RE: Administrative Completeness Determination (Case Drainage Report).

It has been determined that your Development Application 149-SA-2013, Estates at Cochise is administratively complete, and City Staff has begun their substantive review of the application material. Your Development Application is being reviewed under the City's Standard Application Review Methodology.

DRAINAGE REPORT RESUBMITTAL INFORMATION: The drainage report is not approved. Please address the following issues. Provide a written response to each item listed below. State how the issue was addressed/solved and provide the section and page number in the report where the answers are located. Submit two copies of the revised drainage report, the previous drainage report and a response letter. If a response letter is not provided the drainage report will be returned without a review.

This correspondence is a written response to your drainage review comments dated 6/5/13. The content to follow describes how each comment was addressed.

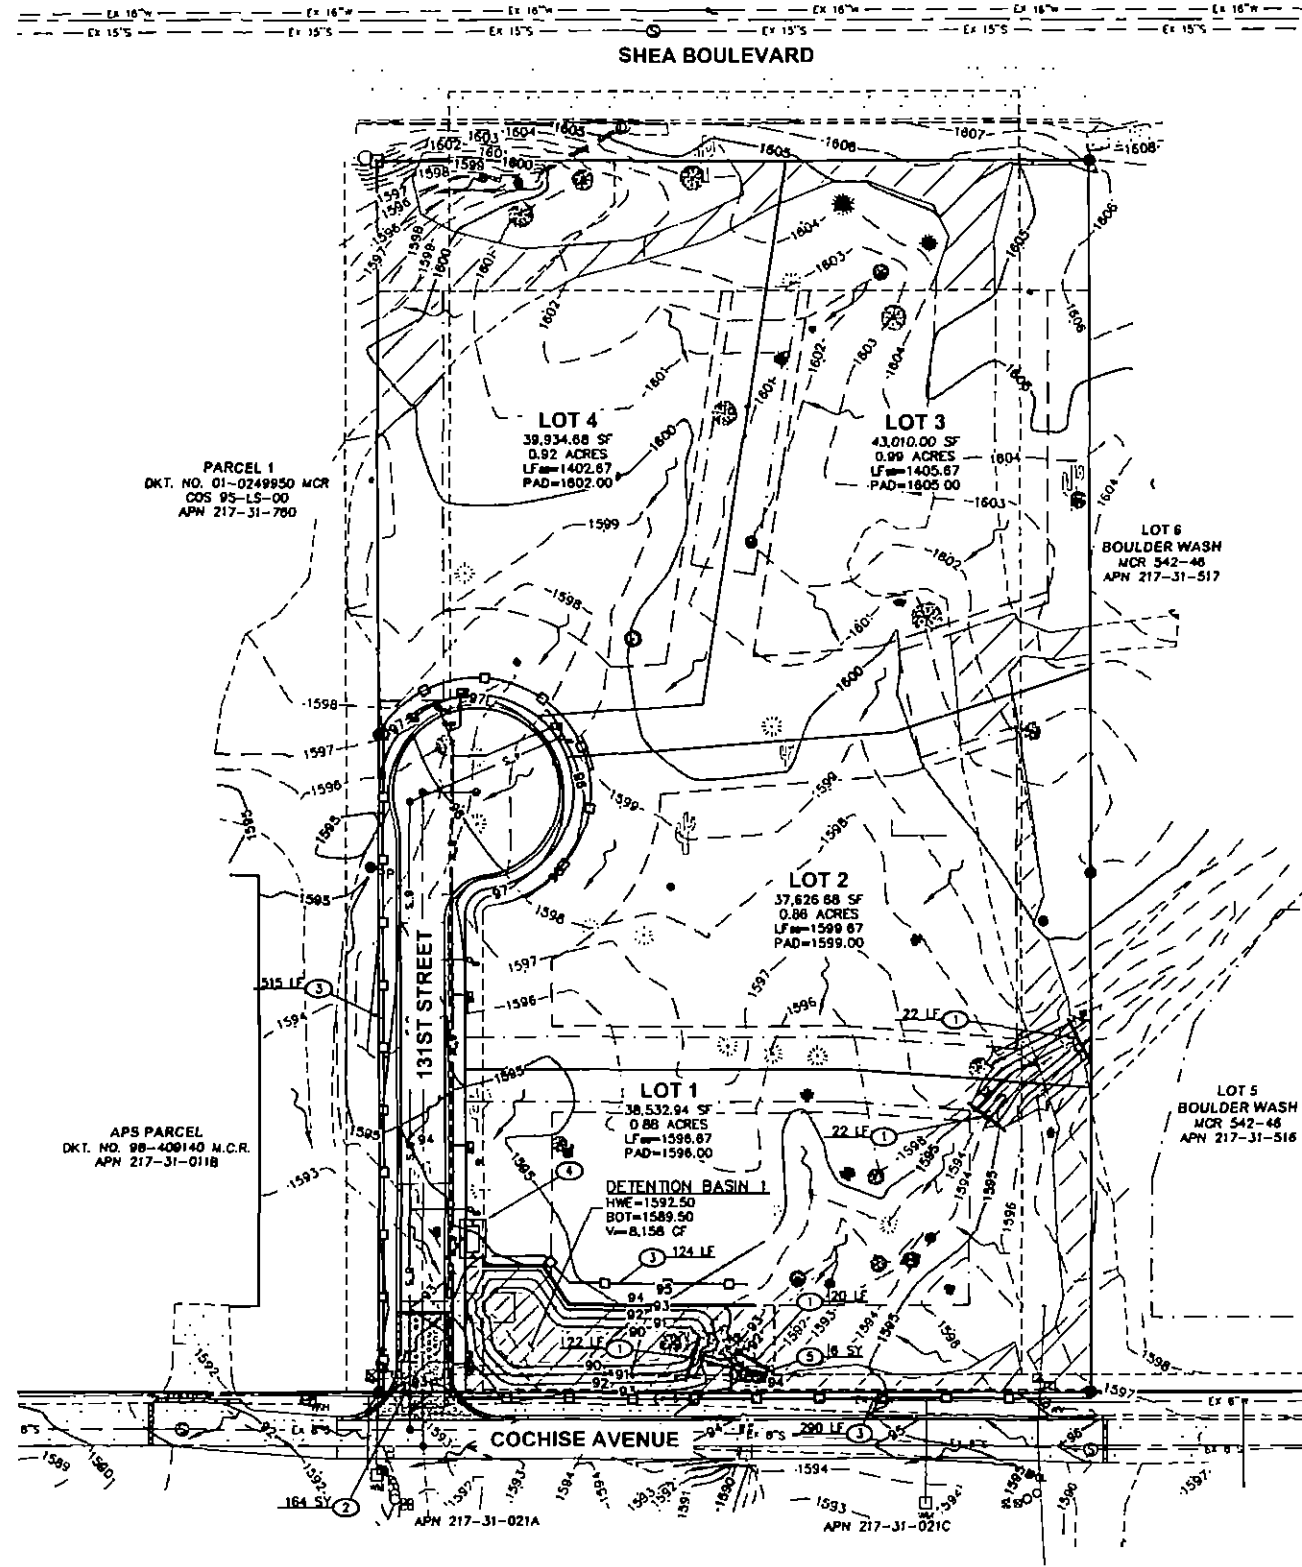
5. **STORMWATER POLLUTION PREVENTION PLAN (SWPP) Trigger:** DSPM CHAPTER 4, Section 4-1.300 Provide detailed drawings and calculations showing the total disturbed areas for these projects. A SWPP is required if the disturbed area, in aggregate, is 1 acre or more. (Note to city staff: check the 2 boxes under ADD ISSUES in the final plan review tab. "Disturbed area greater than 0.9 acres in aggregate.")

5. A SWPPP was created to address total disturbed area listed on the cover sheet and limits shown on sheet SWP02. Half sized copies of the SWPPP can be found in Appendix F of the Drainage Report.
